REMARKS

IN THE DRAWINGS

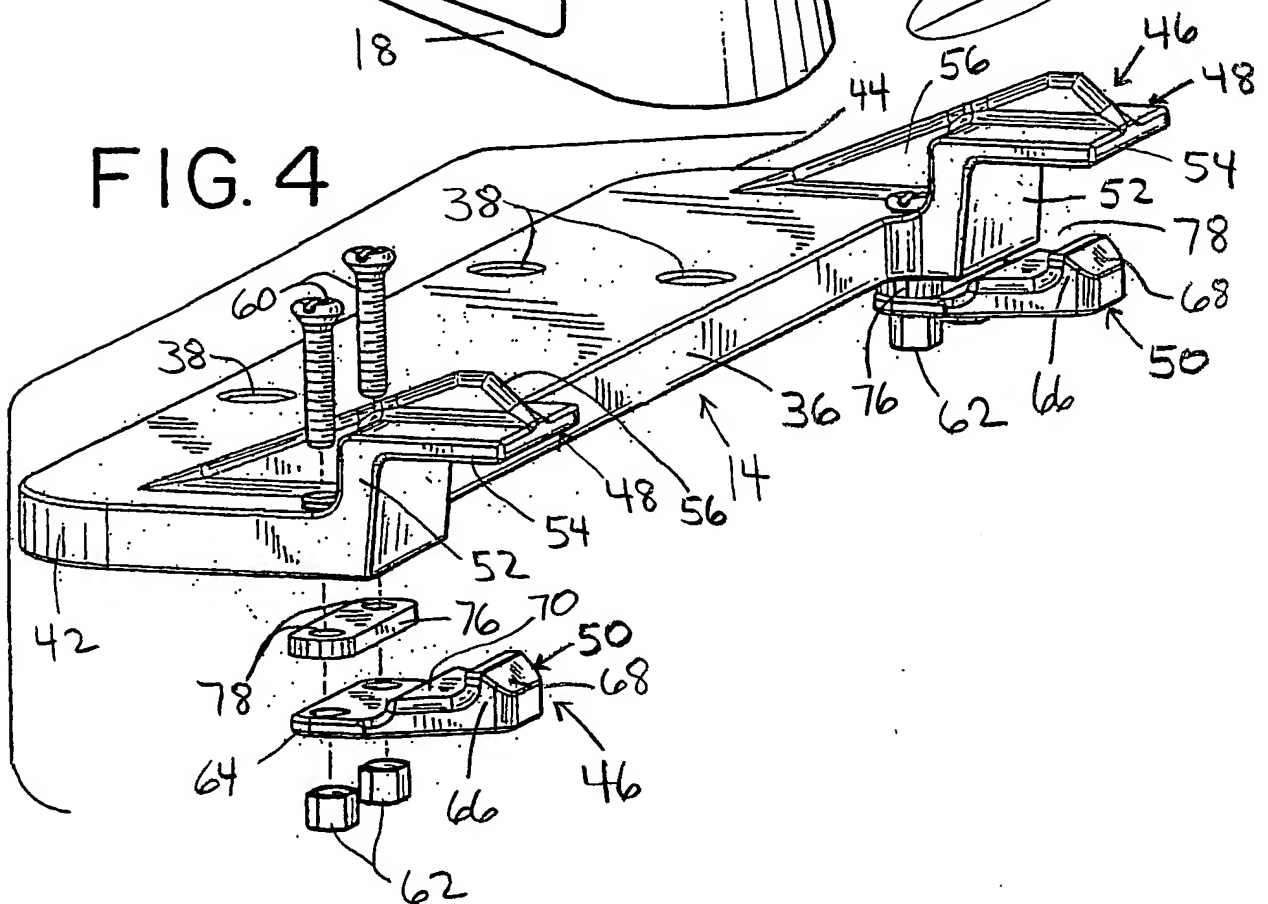
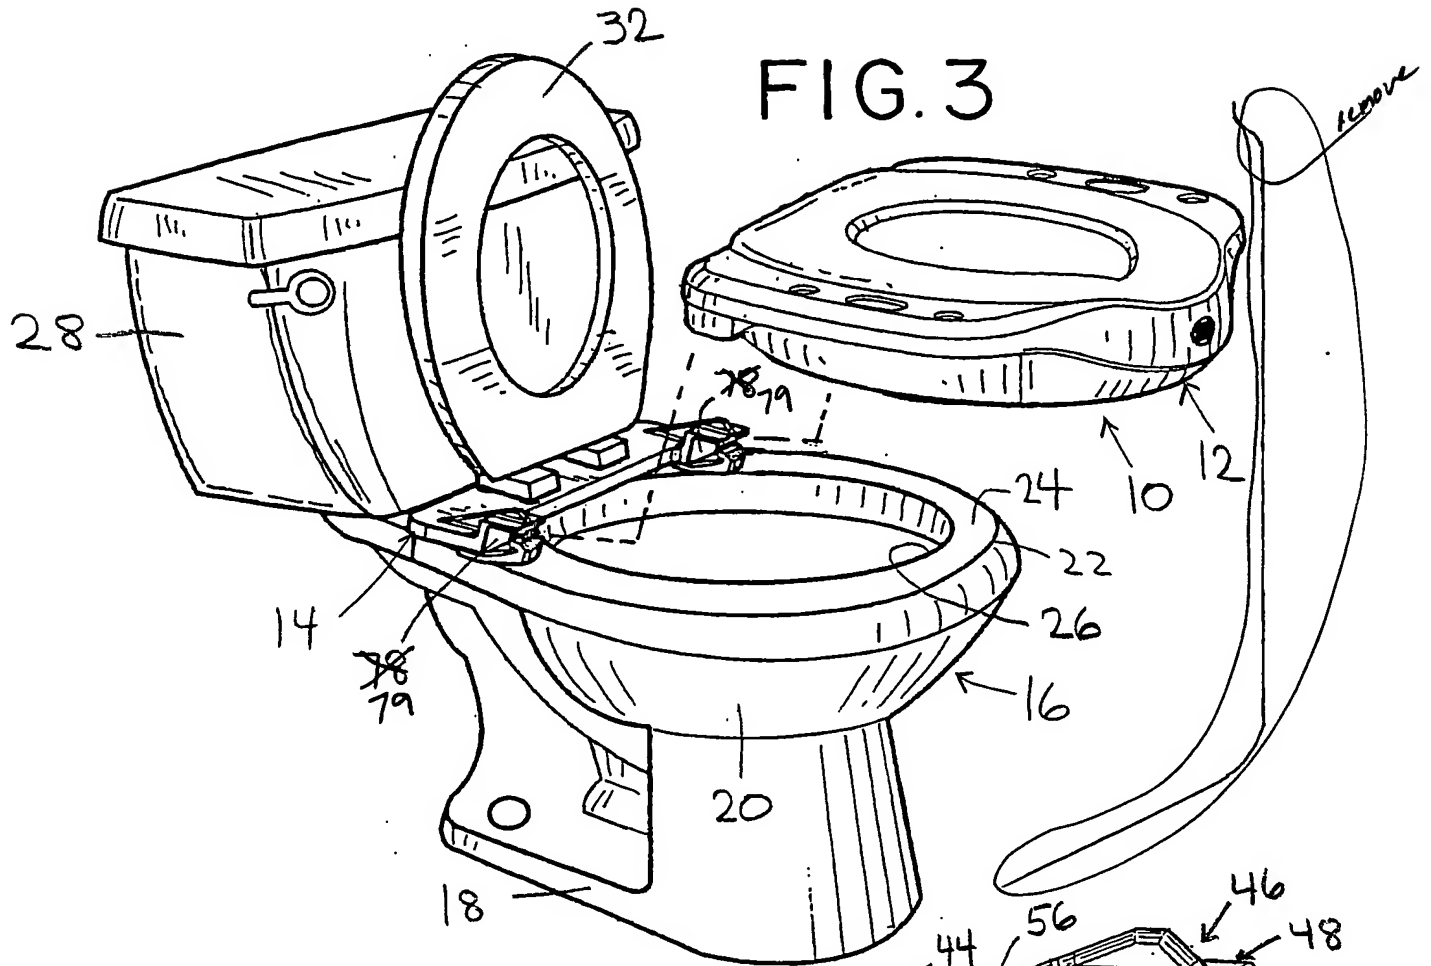
The drawings stand objected to under 37 C.F.R. § 1.84. Applicant submits herewith a set of formal drawings in which corrections were made to the initially filed drawings. As suggested by the Examiner, the angled line bordering Figs. 3 and 4 has been removed. Furthermore, Figs. 3/4 and the specification have been amended to refer to reference number 79 as the receiving socket and to continue to refer to reference number 78 as holes. Accordingly, Applicant requests that the objection to the drawings be reconsidered and withdrawn.

Applicant submits formal drawings marked as “Replacement Sheets” having the corrections requested by the Examiner. Additionally, Applicant submits annotated drawings marked as “Annotated Marked-up Drawings” which show the changes made.
